SUM "Headphone Hum" Workaround

<u> IC8 - LM386</u>

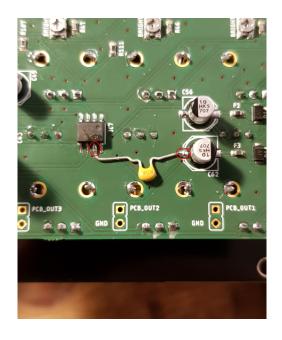
Solder a capacitor between pin 7 and pin 4. Anything between 100nF and 1uF is fine.
